**Interim  
Work Authorization**

Project No.: AIP 3-02-0111-006-2020 / Z675170000

IWA No. 11

Project Name: GST Airport Apron, Runway, and Taxiway Pavement Rehab

# Asphalt Material Handling Map

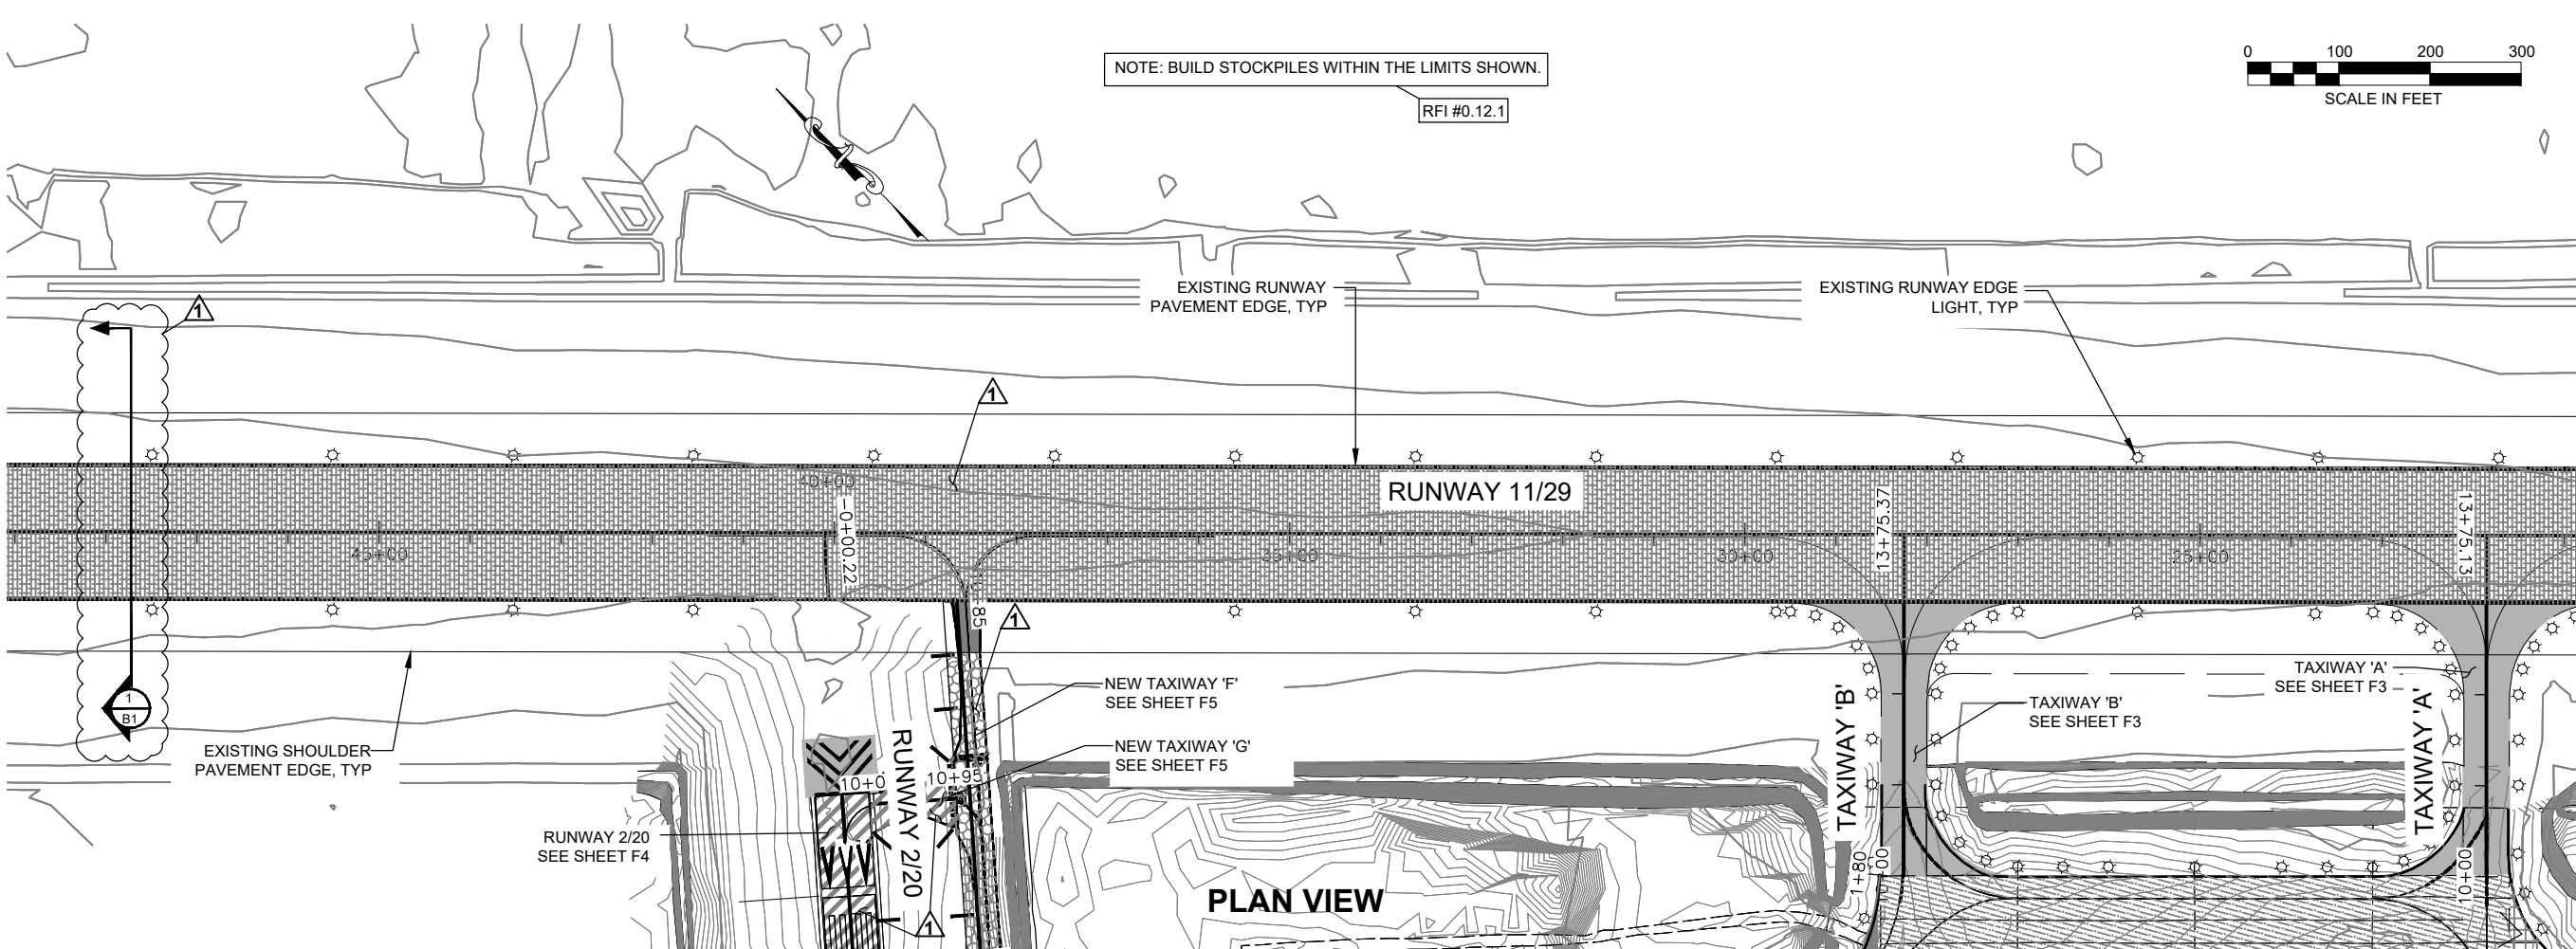
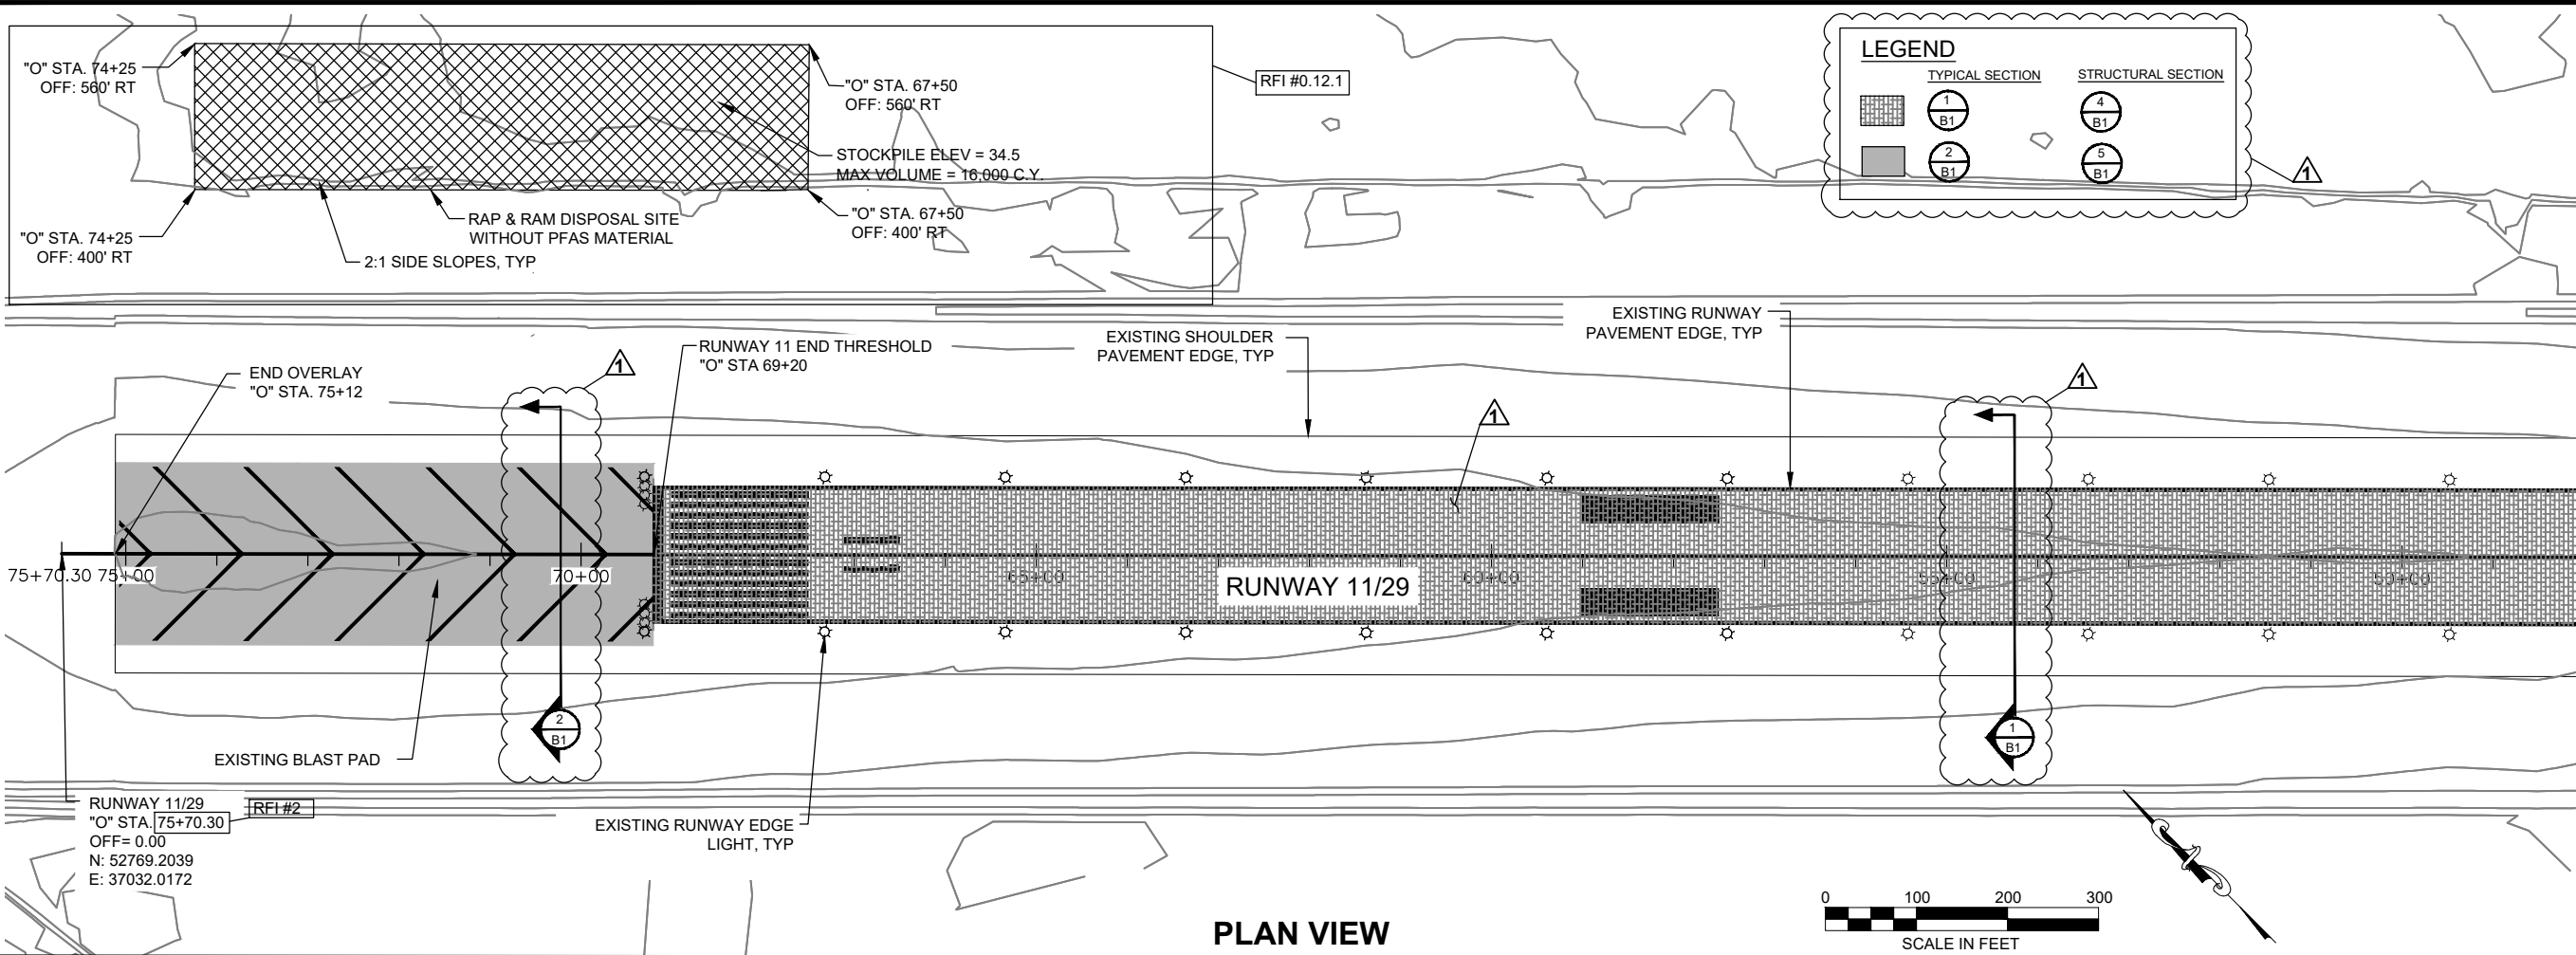
The Basis of Payment for the Work in this IWA has not yet been agreed upon thru the RFP process. This IWA authorizes Time and Materials compensation for the Contractor to haul and stockpile excess RAP that is not used for new HMA, aggregate basecourse, or suitable fill. Excess RAP shall be hauled to its appropriate color-coded location as shown on the attached hauling map. Exact locations of colored zones will be determined in the field by a DOT representative.

- Results Pending
- PFAS Not Detected
- PFAS Detected Below Regulatory Limit
- PFAS Detected Above Regulatory Limit
- - - Airport Property Boundary
- Asphalt may be: 1) recycled into new asphalt, 2) may be blended into the base, 3) may be used as a pad under the PFAS-contaminated liner cell, or 4) stockpiled unlined in RAP Stockpile Location #1
- Asphalt may be: 1) blended into the base in area generated, 2) may be used as a pad under the PFAS-contaminated liner cell, or 3) stockpiled unlined in RAP Stockpile Location #2
- Asphalt may only be: 1) blended into the base in area generated, 2) placed in G.A. expansion area and must be capped at completion, 3) temporarily stockpiled within the area generated, or 4) contained within the PFAS-contaminated liner cell.

4/13/21  
STATE OF ALASKA DEPARTMENT OF TRANSPORTATION AND PUBLIC FACILITIES  
6860 GLACIER HWY, JUNEAU, AK 99811  
(907) 465-1763  
GST AIRPORT APRON, RUNWAY, AND TAXIWAY PAVEMENT REHAB.  
PLAN VIEW - RUNWAY 11/29

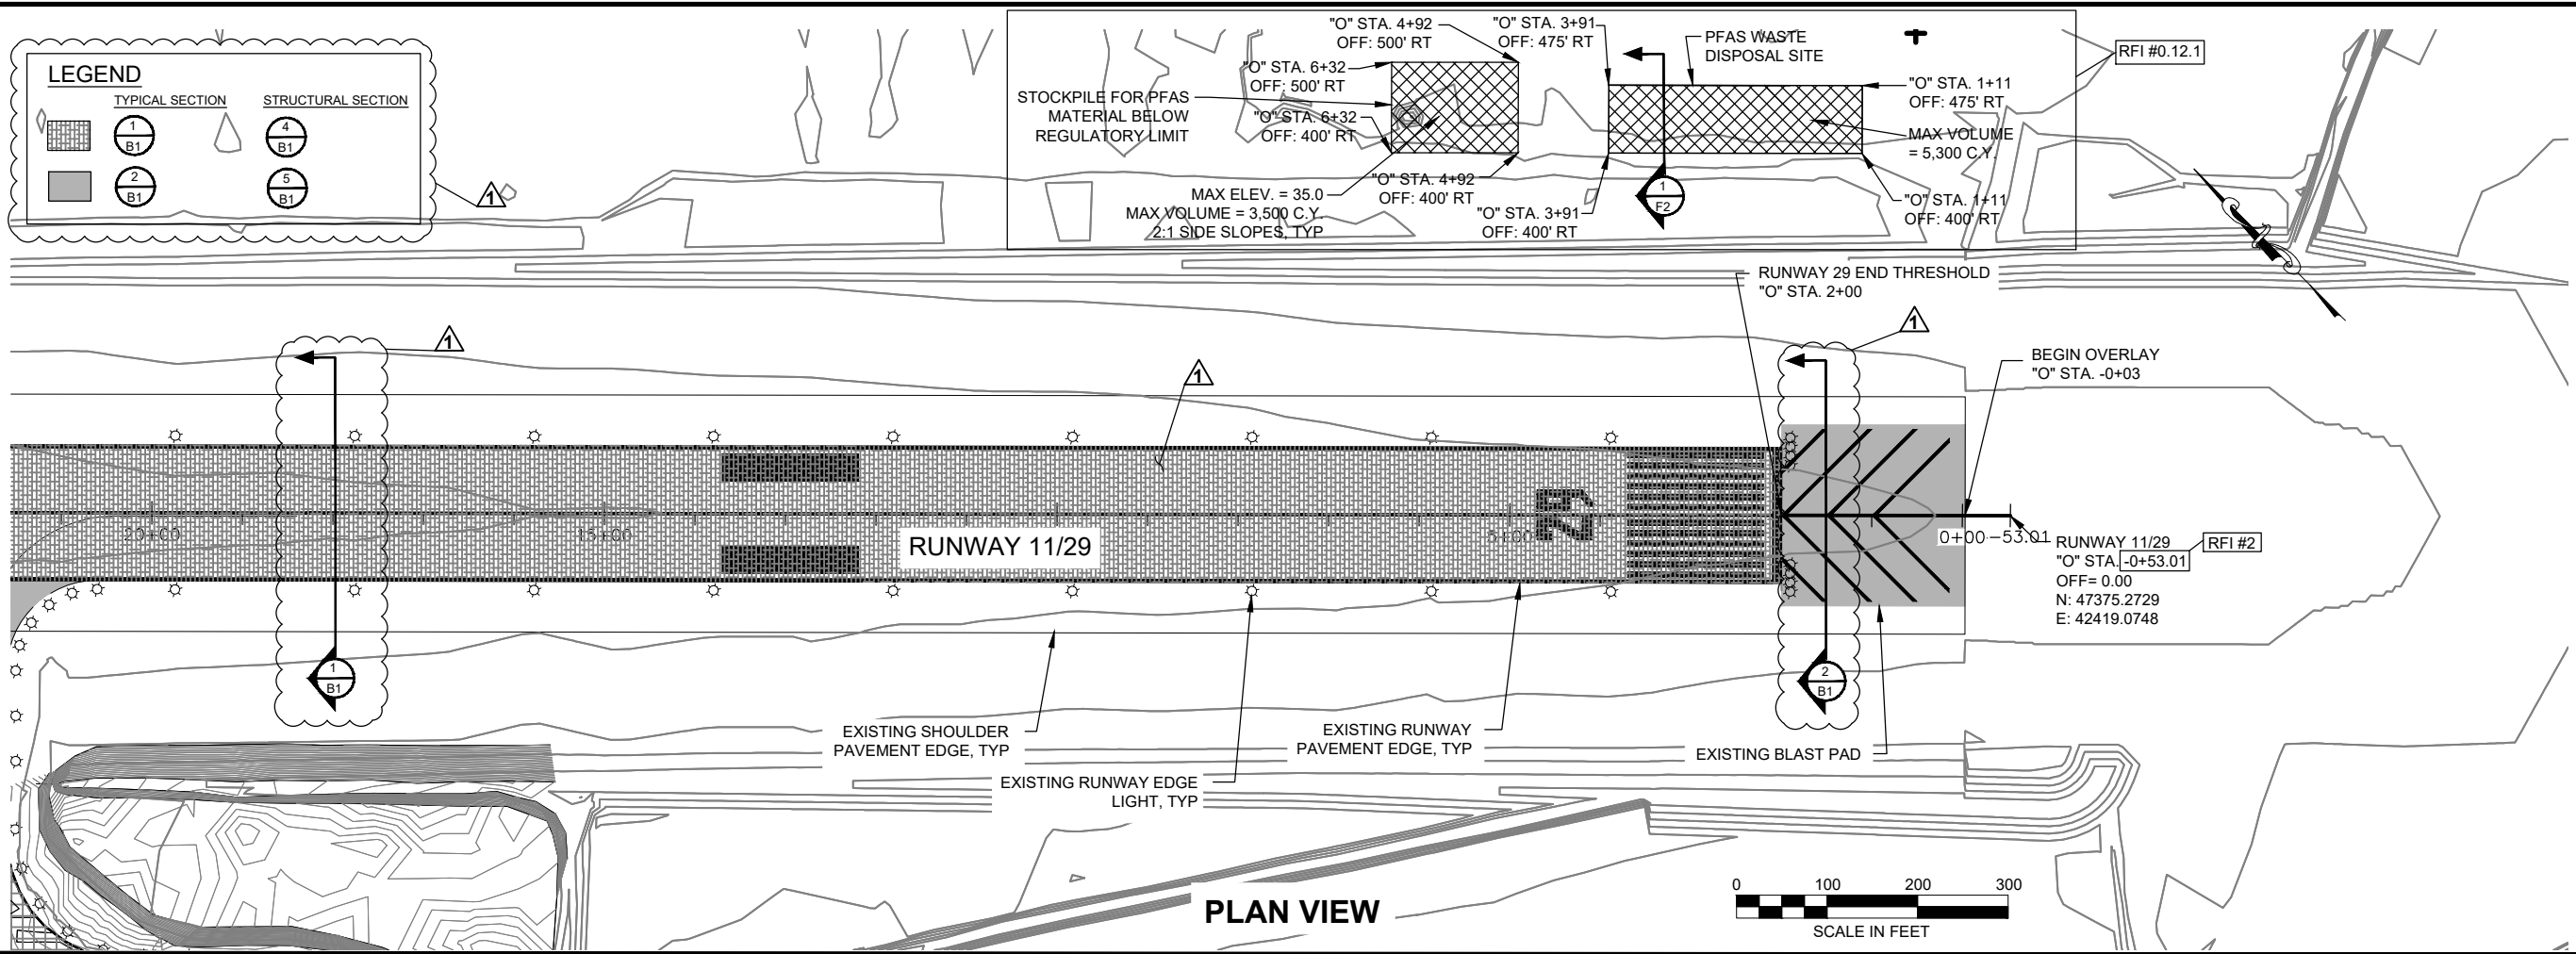
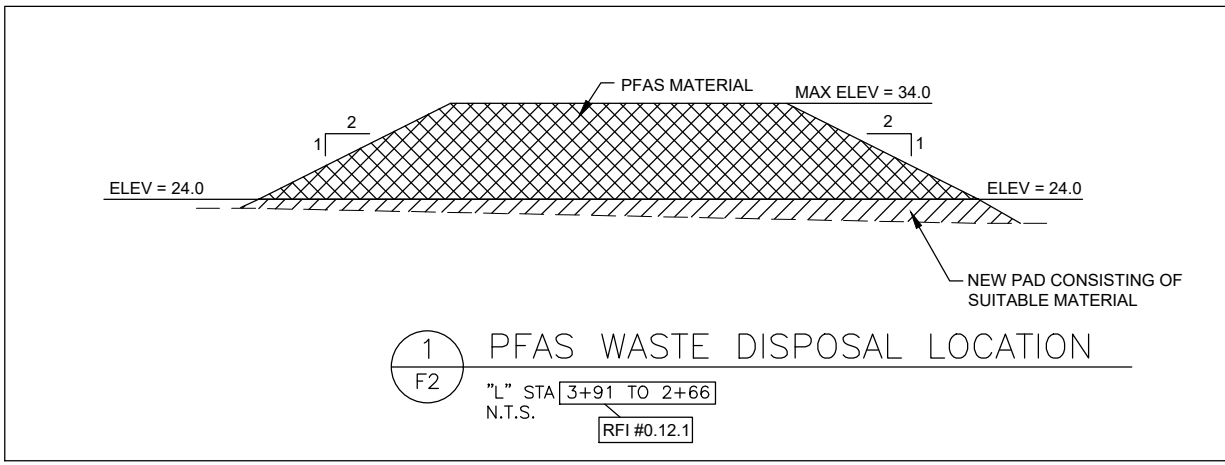
NOTE: BUILD STOCKPILES WITHIN THE LIMITS SHOWN.
